In re application of : **Confirmation No. 2112**
Naoyuki KATOU et al. : Attorney Docket No. 2004_0546A
Serial No. 10/821,942 : Group Art Unit 2614
Filed April 12, 2004 : Examiner Con P. Tran
ACOUSTIC SIGNAL-PROCESSING : **Mail Stop: AF**
APPARATUS AND METHOD

SUBMISSION OF FORMAL REPLACEMENT DRAWINGS

Fig. 4

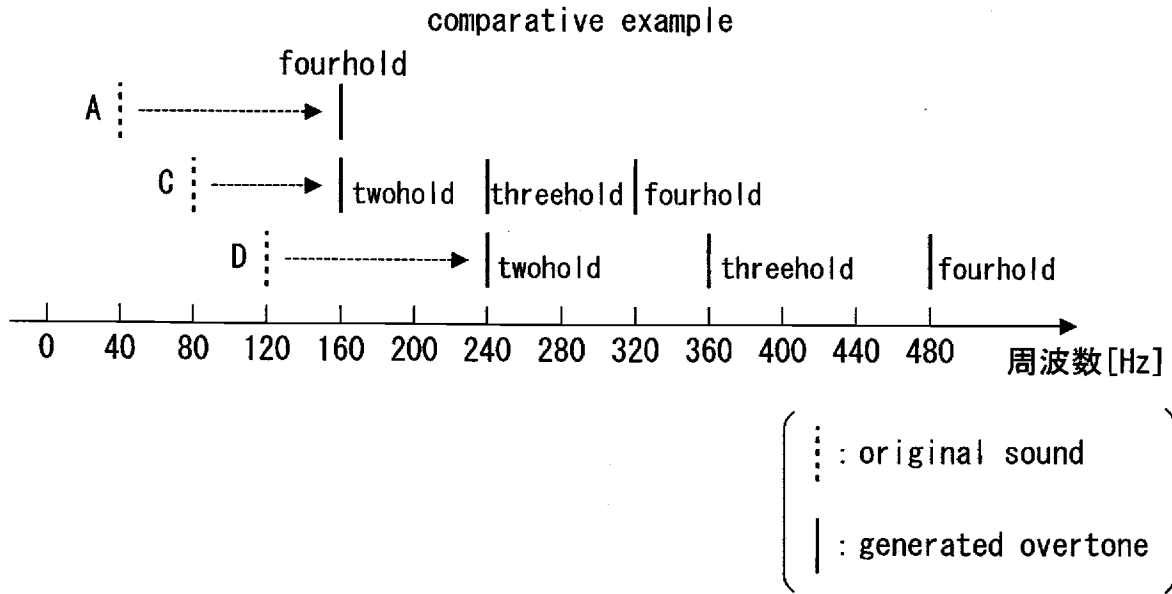
Enclosed herewith are 2 sheets of replacement formal drawings for Figs. 4, 5(a), 5(b), 6(a) and 6(b), marked as "Replacement Sheet" thereon. In each of the above-noted drawings, a minor typographical error has been corrected, namely, the frequency band "E" has been replaced with the frequency band "D" in order to be consistent with the description in the specification.
